February 14, 2008

**RE: RESPONSE TO PUBLIC COMMENT AND APPROVAL WITH MODIFICATIONS  
SOIL-VAPOR SAMPLING AND ANALYSIS PLAN FOR THE U. S. DEPARTMENT  
OF ENERGY/SANDIA NATIONAL LABORATORIES' MIXED WASTE  
LANDFILL  
SANDIA NATIONAL LABORATORIES, EPA ID NM5890110518  
HWB-SNL-05-025**

Soil Gas VOC, Tritium, and Radon Sampling Locations, Mixed Waste Landfill

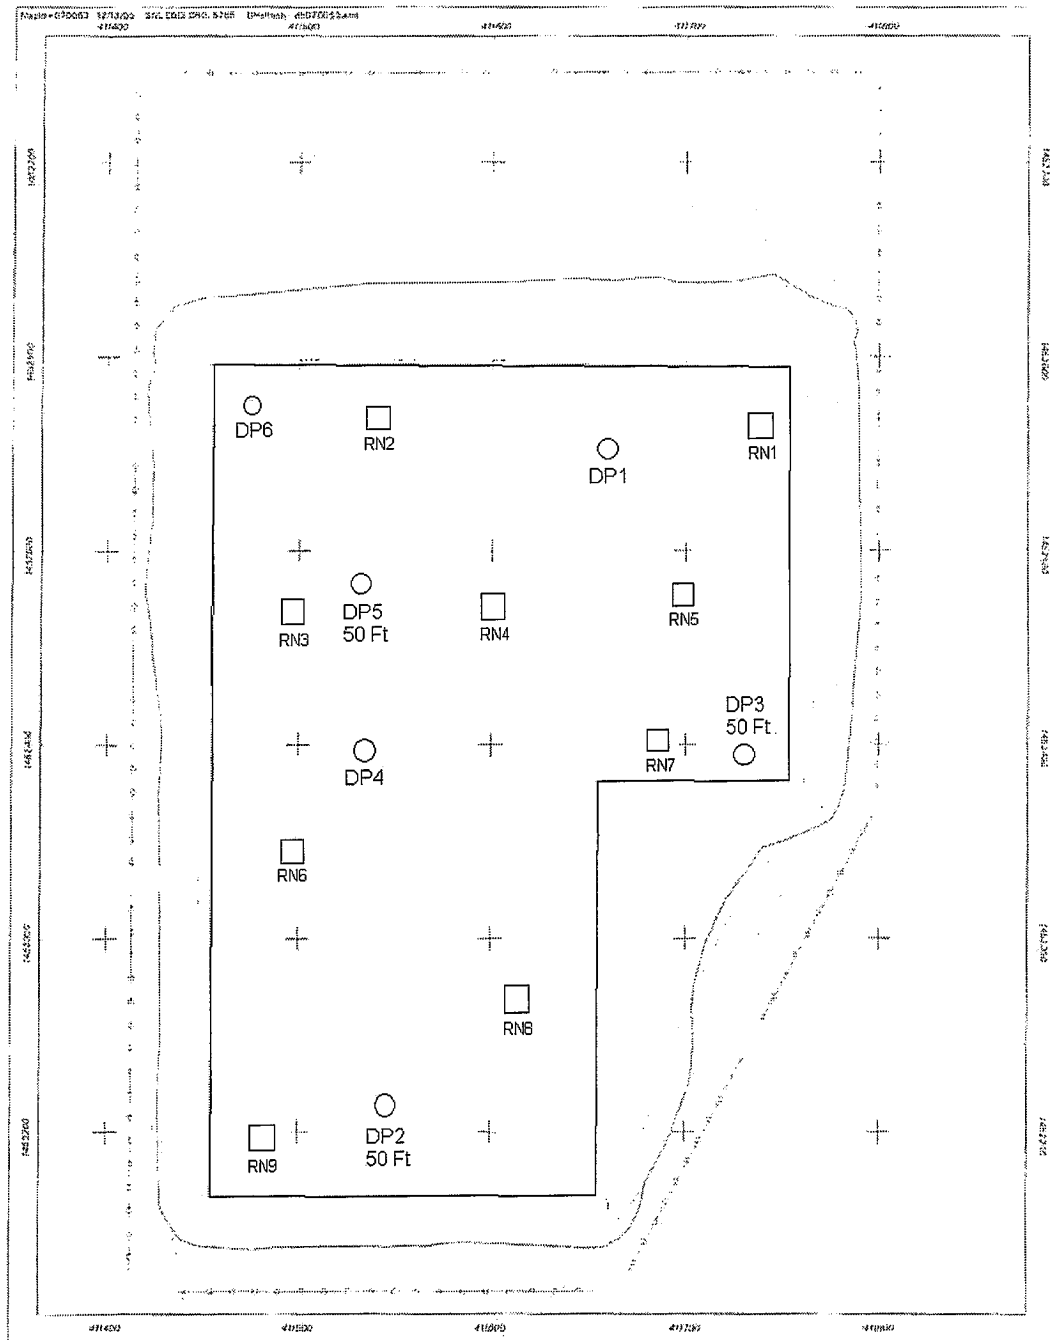
1. Six boreholes for the collection of soil gas and soil samples shall be drilled at the locations shown on the enclosed map (at locations DP1-DP6). Two other boreholes (DP7 and DP8), planned for background locations southwest of the landfill, may be drilled at the background locations as proposed in the SV SAP.

Soil-gas and soil samples from DP1-DP8 are to be analyzed for volatile organic compounds (VOCs) and tritium, as appropriate, as described in the SV SAP. As shown on the enclosed map, the locations for DP4 and DP5 shall be the same as those shown on Figure 2-1 of the SV SAP; the rest of the boreholes, DP1-DP3 and DP6, are to be moved to different locations (see the enclosed map) because of the heterogeneous nature of waste placed into the MWL. To protect workers, the borehole locations for DP1-DP6 may be adjusted by a maximum of 20 feet in any horizontal direction to avoid drilling directly through waste buried in the MWL.

4. Nine radon detectors (RN1-RN9) shall be deployed at the locations shown on the enclosed map. These locations were selected, in part, based on the highest flux rates for radon as determined in the 1997 survey, and do not include the two background locations proposed in the SV SAP. The locations for RN1, RN3, RN4, RN5, RN6, RN7, and RN8 correspond to locations 30, 5, 8, 44, 13, 64, and 18 of the 1997 survey, respectively. The locations of RN2 and RN9 are new.
